MA		
LL.	NAME & TITLE	THOMAS J. STOSUR, DIRECTOR	CITY of BALTIMORE MEMO	
	AGENCY NAME & ADDRESS	DEPARTMENT OF PLANNING 8 TH FLOOR, 417 EAST FAYETTE STREET		TWORE ALIC
	SUBJECT	CITY COUNCIL BILL #14-0378/Zoning – Conditional Use – Amending Ordinance #13-176		1797
T 0			DATE:

STAFF REPORT

REQUEST: CCB #14-0378/Zoning - Conditional Use - Amending Ordinance #13-176

Exhibit 1: Updated Site Plan - As Introduced

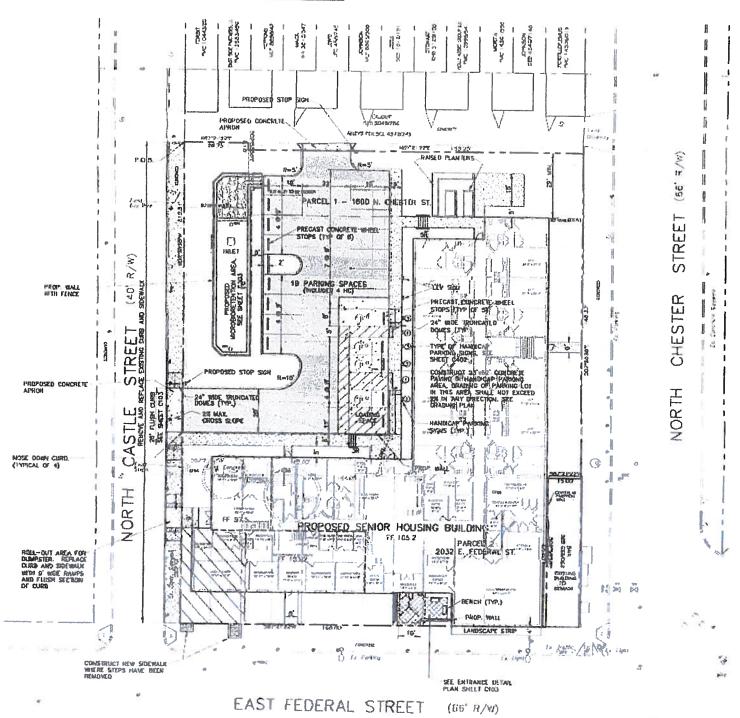
The site plan, although substantially similar to that included at introduction of this bill, has shifted slightly in the development of the final construction documents, resulting in a rear yard setback of only 28 feet at this time. Therefore, staff is recommending that this bill be amended to reduce the rear yard setback requirement to 25 feet, which would allow the updates to the site plan and provide for any additional adjustments as a result of the design process. Additionally, the site plan is proposed to be amended, replacing Exhibit 1 with Exhibit 2, to reflect this change (see Exhibits, attached).

RECOMMENDATION: Approval with an amendment to decrease the requested rear yard setback requirement from 29 feet to 25 feet as a result of a minor site plan change during the development of the construction documents and to amend accordingly to the version presented in Exhibit 2 of the Staff Report dated May 29, 2014.
